# Certificate of Appropriateness

**Property** 1702 N. HUMBOLDT AV. **Brady Street Historic District**  
**Description of work** The church, rectory and garage will be tuck-pointed in areas as needed. Test panels will be done in inconspicuous places on the buildings for HPC staff to review and approve. On the school, the chimney in the back of the building will be demolished, decked-in and roofed-over with shingles to match.

**Date issued** 10/31/2014 **PTS ID** 98733 **COA, tuckpointing, removal of chimney on school**

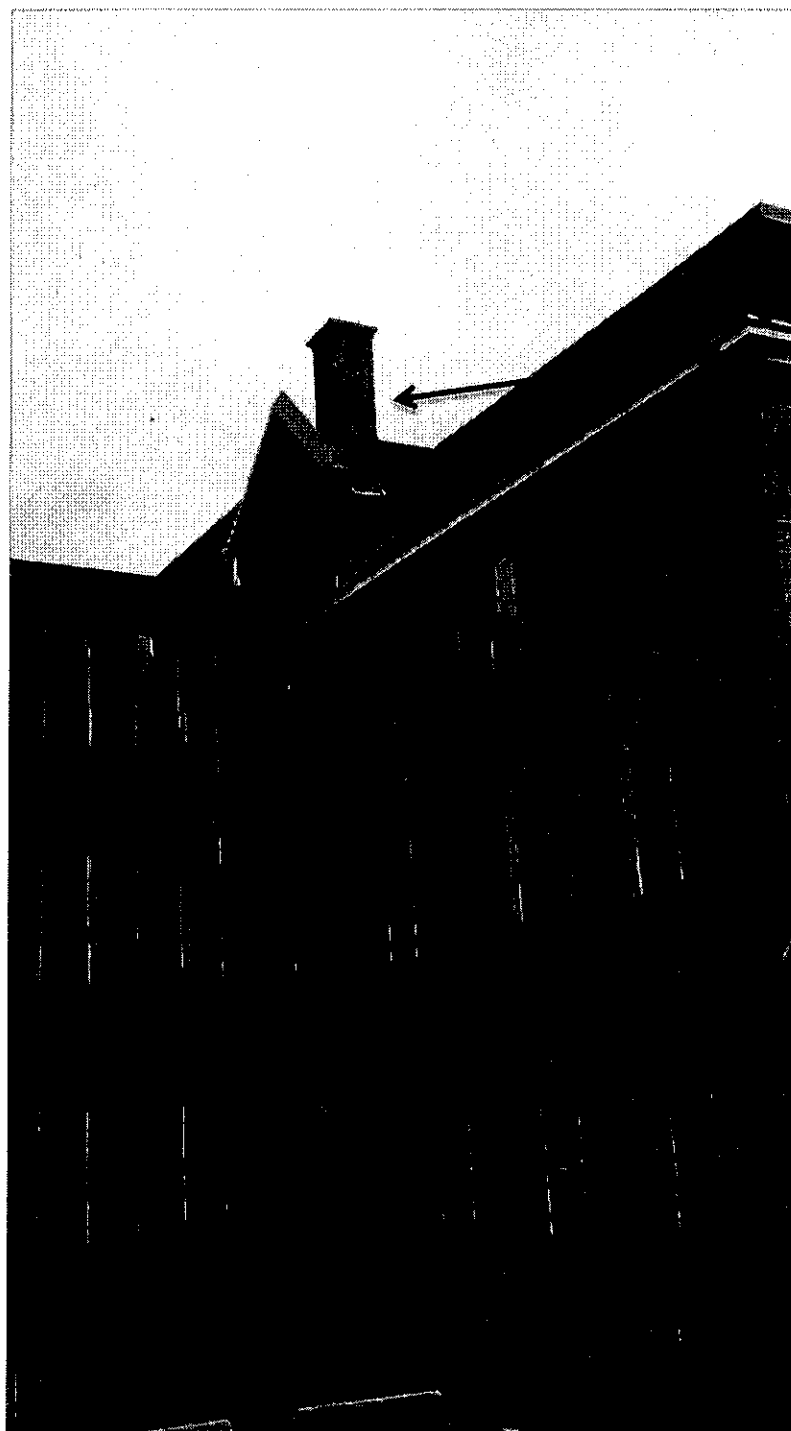
**Remove chimney on north elevation only.  
Patch roof deck and install new shingles to  
match existing.**

**This test panel on the rectory (East Elevation) shows some wobble in the butter joint that was cut and re-pointed. This must be avoided and only mortar that is missing, loose or deteriorated should be replaced. Otherwise the color and texture of the replacement mortar in this panel is acceptable.**

Test panel on garage (west elevation) is acceptable.

Mortar sample on church is acceptable in terms of color, texture and joint width and finish. Where new bricks are needed, they must be common cream brick of the same size, color and texture as the originals.
